**Submission from the Maules Creek
Community Council (MCCC)**

**Maules Creek Coal Mine
Continuation Project**

Project Application Number: SSD-63428218

4.8.2025

Figure 5-5 Top of Boggabri volcanics (AGE 2021 and 2025)

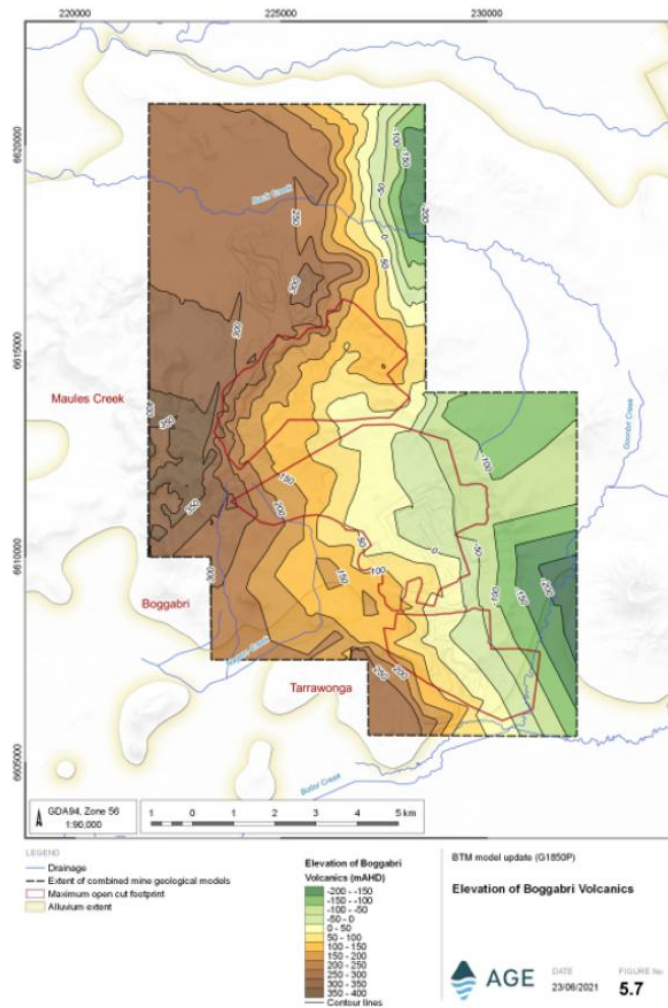
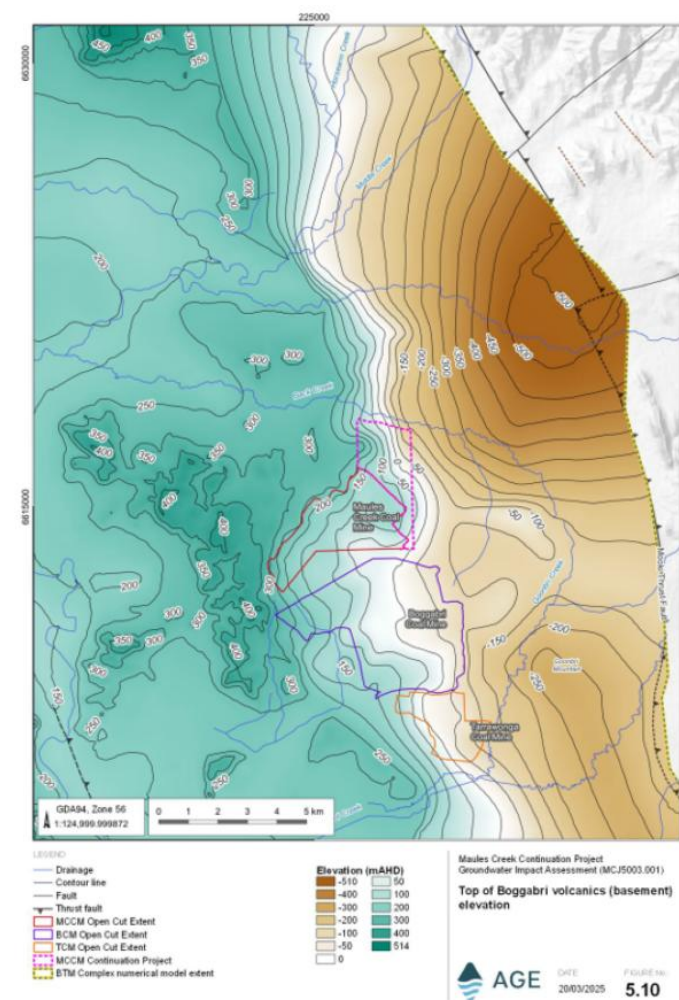
A key input to the groundwater model is the representation of the Boggabri Volcanics basement surface. The Boggabri Volcanics basement surface which is represented in the AGE 2025 report is significantly different to that presented in previous reporting (AGE, 2011 and AGE, 2021). Figure 5-5 shows the comparison between the Boggabri Volcanics basement surface presented in AGE (2021) versus AGE (2025).

Approaching Maules Creek, AGE (2021) shows the top of the Boggabri Volcanics rising toward the west, with elevations approaching 250 mAHD, and dipping westward to below -150 mAHD, forming a clear east west gradient (Figure 5-5). AGE (2025) confirms the presence of this east west gradient and westerly structural high but introduces a steeper elevation gradient from east to west. This difference indicates that an update or reinterpretation of the Boggabri Volcanics surface must have been carried out between 2021 and 2025. However, there is no mention of additional drilling that has been completed between 2021 and 2025 in this area to warrant the reinterpretation of the Boggabri Volcanics structure contours. The source dataset used to generate the Boggabri Volcanics surface is not specified and further clarification is needed to understand why this was carried out and the implications this has on the model calibration and predictions.

Figure 5-6 Top of Boggabri Volcanics (Pacific Coal, 1982)

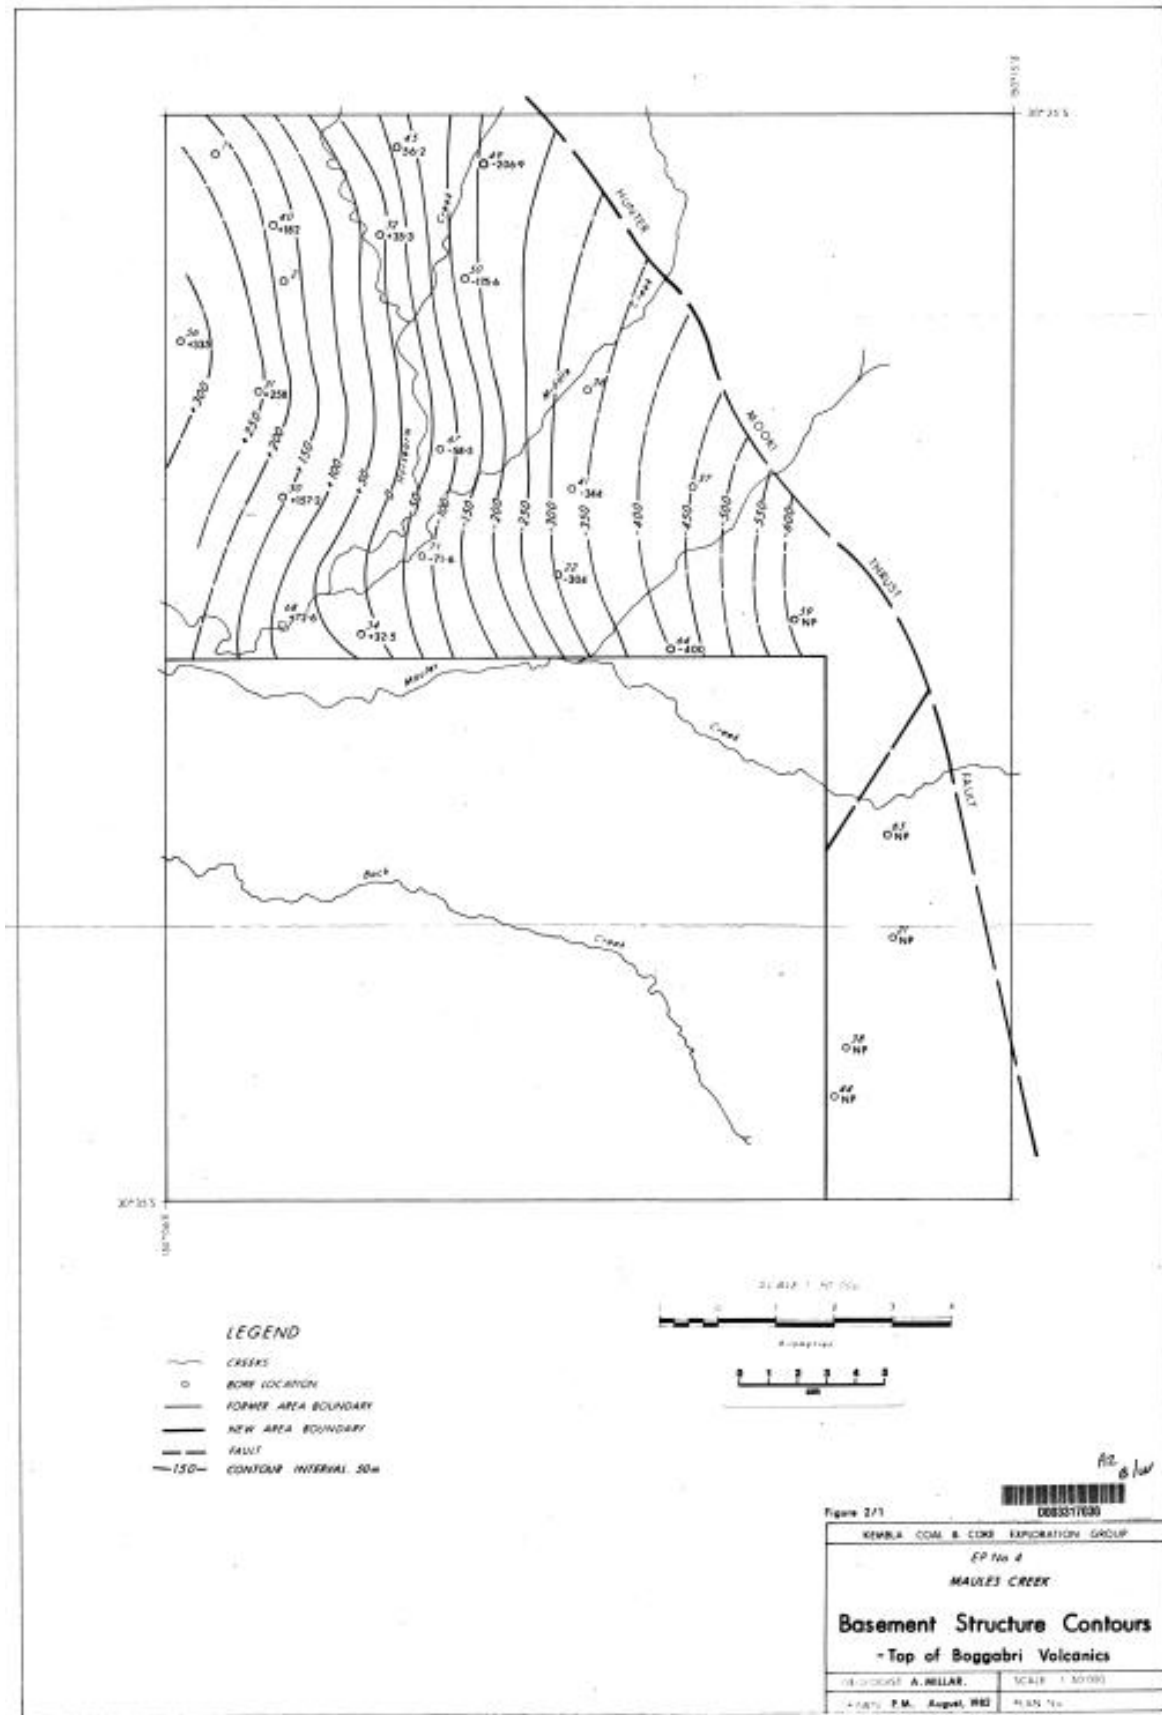
An additional map showing the top of the Boggabri Volcanics is shown in Figure 5-6. This figure is contained within a coal exploration report (Pacific Coal, 1982) which was downloaded from NSW DIGs. The map also shows the location of numerous coal exploration drill holes that were used to interpret the top of the Boggabri Volcanics.

Figure 5-7 Markup of hydrogeological conceptualisation B-B' (AGE, 2025)

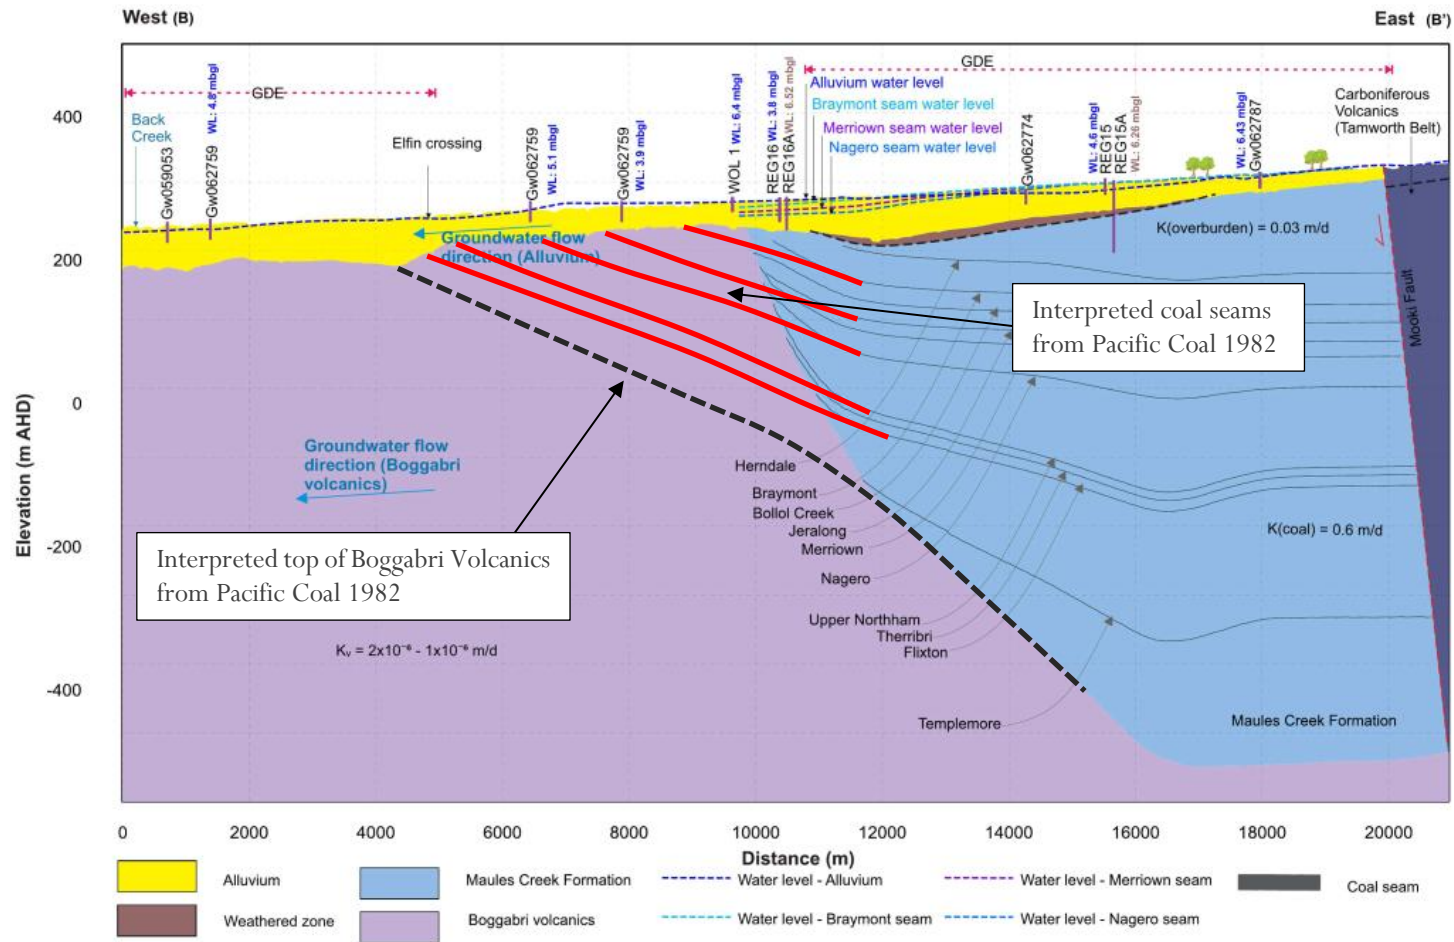
It is important to note that the described content cannot be found or substantiated in Appendix F. None of the hydrogeological conceptualisation sections presented demonstrate a potential hydraulic connection where coal seams directly sub crop beneath the Maules Creek alluvium, thus allowing a potential or hydraulic connection between the alluvium and the coal seams such as the Braymont Seam. The conceptual models, such as conceptualisation section B-B' (reproduced below as Figure 5-1) shows a strong disconnection. The alluvium is generally shown to be separated by low-permeability units. The Herndale and Braymont Seams terminate before they reach the base of the alluvium.

Figure 2. Goodness of fit between observed and modelled data. Right: AGE 2014 old model. Left: AGE 2017 updated model.

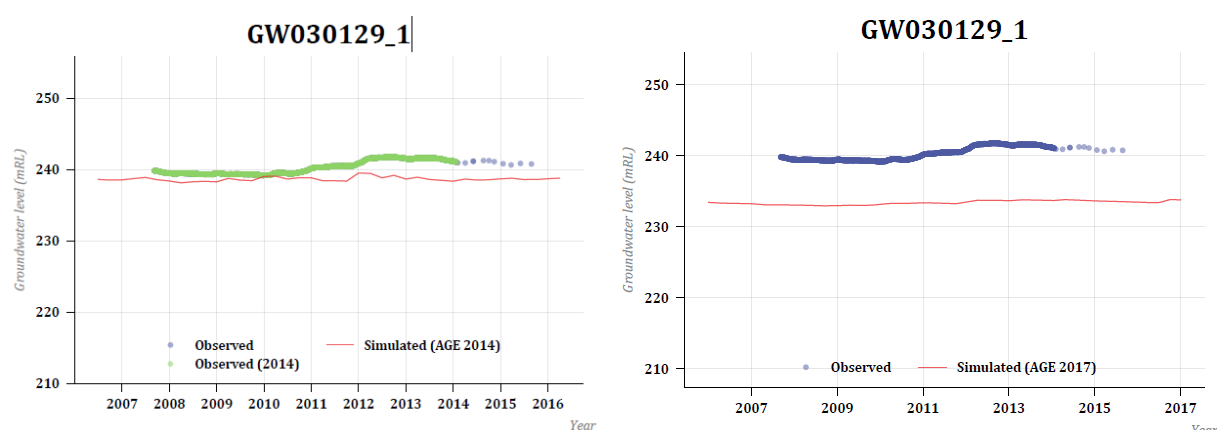
Figure 2 shows that an old model (AGE, 2014) has in some cases simulated groundwater level more closely than the new model (AGE, 2017). Figure 3 shows that the new model (AGE, 2017) simulation of seasonality in some cases is poorer than the older model (AGE, 2014). There are also examples of poorer simulation of trend (AGE, 2017).

Figure 3. Representation of seasonality in the old and new models. Right: AGE 2014 old model. Left: AGE 2017 updated model.

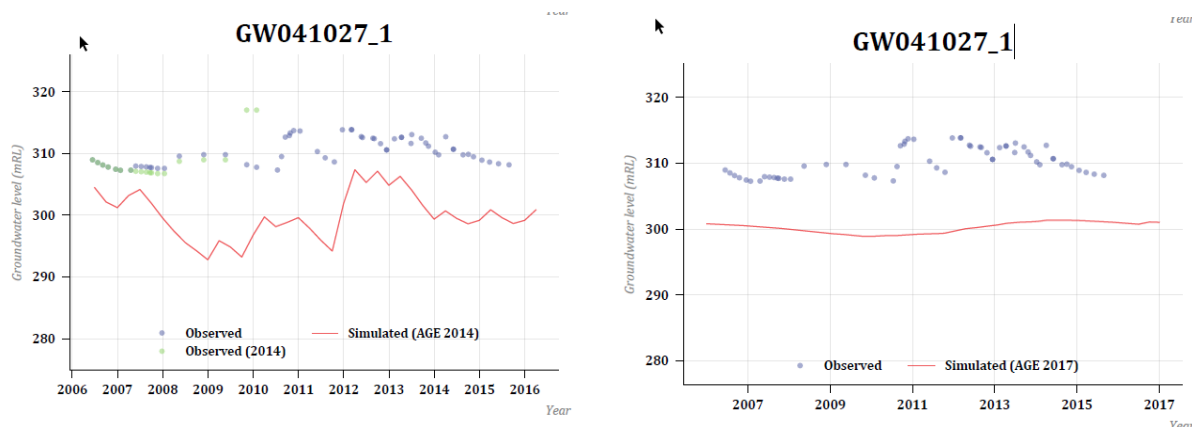
There is also evidence that the new model (AGE, 2017) has performed poorer than previous models (e.g. AGE, 2014) in terms of simulating groundwater exchanges between various strata, e.g. the alluvium and bedrock.

Figure 4. Observed and AGE (2014) Model calculated groundwater heads at different depths. Left: Alluvium (GW967138: shallower) vs Jeralong (v1: deeper). Right: Merriown (V2: shallower) vs Nagero (V3: deeper)⁴, indicating downward hydraulic gradient and groundwater flow (see Figure 1 for location).

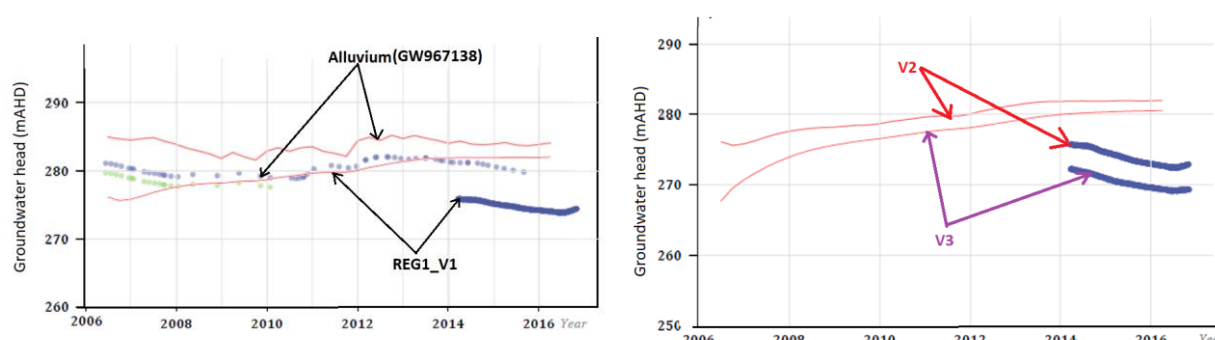
The groundwater head observations presented in Figure 4 (Left) show decrease in head with depth in the strata that underlie the alluvium. So, groundwater head observations in the area indicate downward hydraulic gradient and, subsequently, downwards groundwater flow.

Figure 4 shows that the old model (AGE, 2017) generally successfully simulates observed field conditions. However, the new model (AGE, 2017) completely reverses hydraulic gradient and the groundwater flow direction (Figure 5). This shortcoming in the model simulation critically affects its ability to serve as a prediction tool for licensing and impact prediction purposes.

Figure 5. AGE (2017) Model calculated groundwater heads at different depths (Alluvium: shallowest, V2: in-between, V4: deepest)⁵ suggesting upward hydraulic gradient and groundwater flow (see Figure 1 for location).

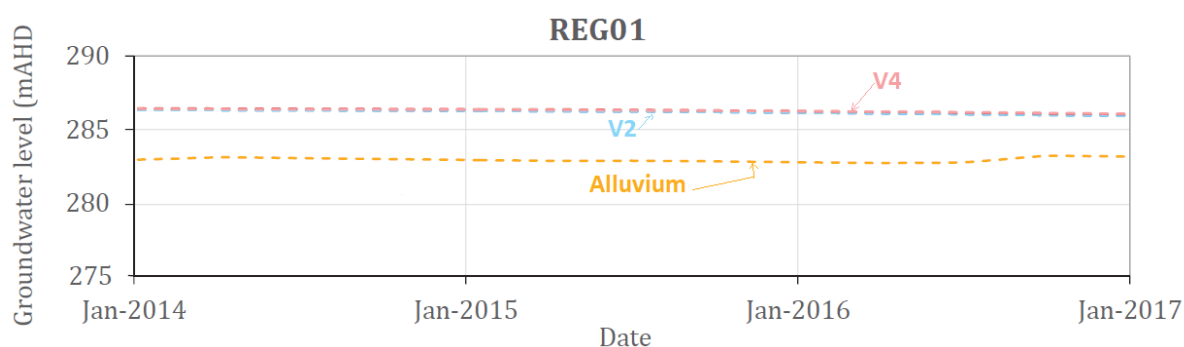
It appears that the AGE (2017) model may be combining geological units into numerical model layers ineffectively, e.g. lumping the Jeralong, and Merriown coal seams into numerical model layer 8, missing the chance for better model representation and calibration

Figure 6. Two sets of observation data from the same monitoring site.

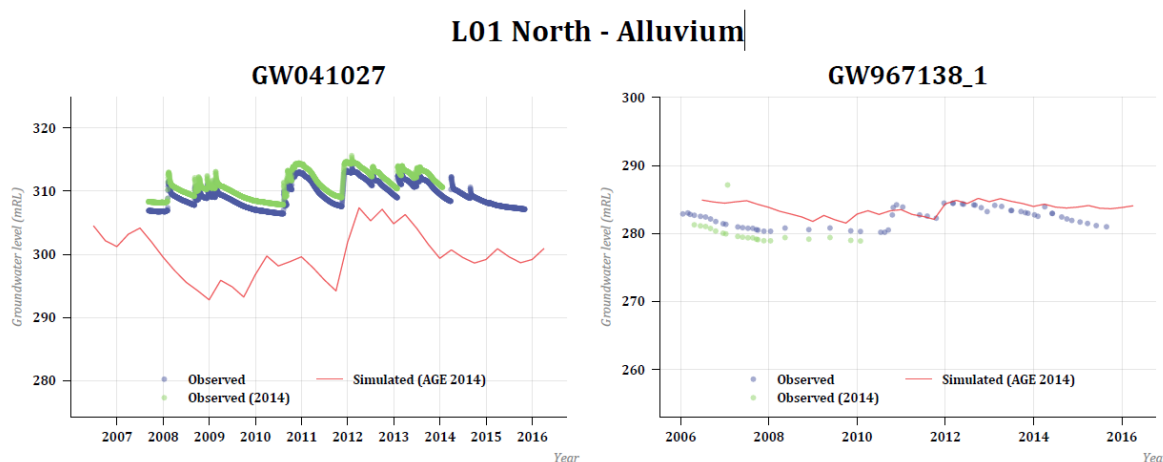
- The presentation of two observation data sets in the L01 North - Alluvium hydrographs in Appendix B is confusing (Figure 6). A “useful” legend is needed to relate data to their respective piezometers. Also, clarification is needed to which dataset is used to calibrate the model.

Figure 2: Groundwater monitoring locations (taken from Annual Review, page 55)

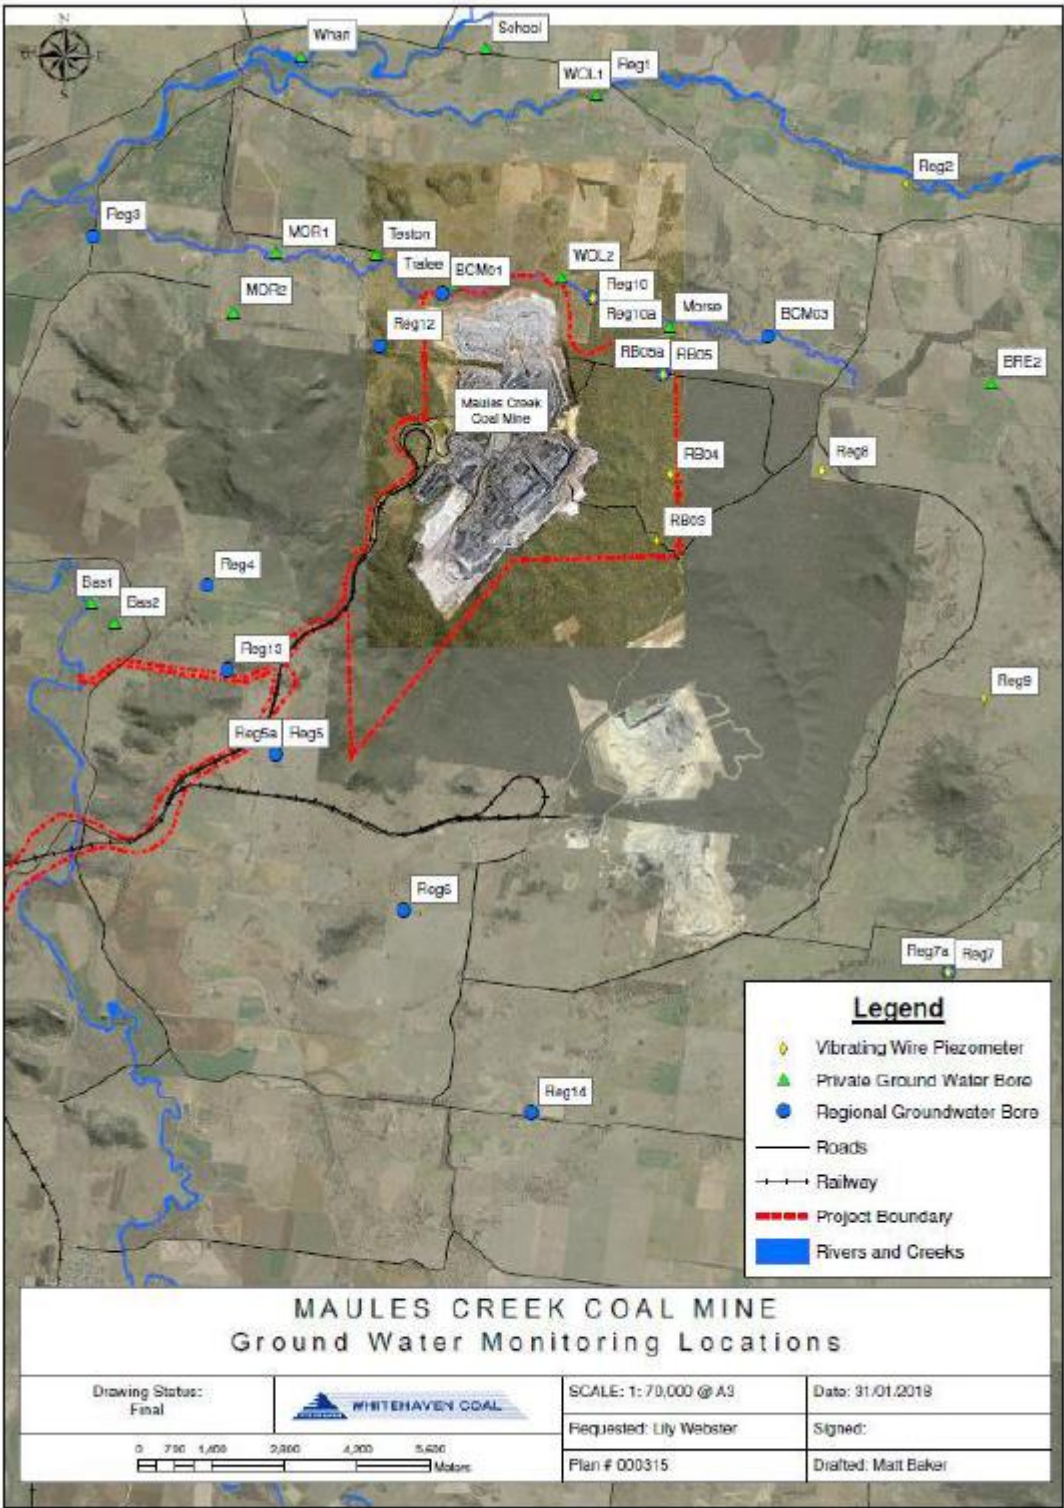
2	Groundwater level data	<p>Dol Water has a number of concerns about the groundwater level data presented in the Annual Review (page E99-E112):</p> <ul style="list-style-type: none"> Figure 9 (page 54) does not include all monitoring points, but only those reported on for the last year The symbols used Figure 9 are unclear for Reg7, Reg7a, Reg10, Reg10a, RB05 and RB05a and possibly missing for Reg1 (elsewhere called Reg01). Data for the regional and private bores is presented in tabular rather than figure form Data for the VWPs is presented with varying y-axis scales, making comparisons difficult Only data from 2017 is presented Depths are not provided for the regional bores, private bores or vibrating wire piezometers (VWP) The monitoring depth/formation is not presented for the regional or private bores Declining trends of 5+ meters evident in some of the VWP data – trend analysis not included Apparent data errors (e.g. step changes) evident in some of the VWP data – error analysis not included Groundwater level data are not synthesized (e.g. in maps showing hydraulic head contours, or in cross sections showing vertical and horizontal gradients) or set in the larger regional hydrogeological context Groundwater level data are not compared against historic data, modelled predictions or trigger levels (n.b. the groundwater trigger levels in the WMP (page 121-122) need to be clarified) – long term trend analysis not included. <p>Dol Water recommends Annual Review is revised to include:</p> <ul style="list-style-type: none"> Groundwater level data is presented for all monitoring points in the network, not just those monitored in 2017, and presented in figure form Groundwater levels are not limited to the reporting year but to the full dataset, groundwater levels are to be quantitatively analyzed for trends Groundwater levels are compared against modelled predictions and trigger levels Groundwater levels are interpreted via maps showing hydraulic head contours and in cross sections showing vertical and horizontal gradient <p>Dol Water further suggests the Annual Review is revised to also address all other concerns raised above.</p>	<p>Response not explicitly given by MCCM. Unknown if this is because DPE passed on table or not.</p> <p>Dol Water recommends that this table is provided to the proponent, and all matters contained in it are addressed.</p>
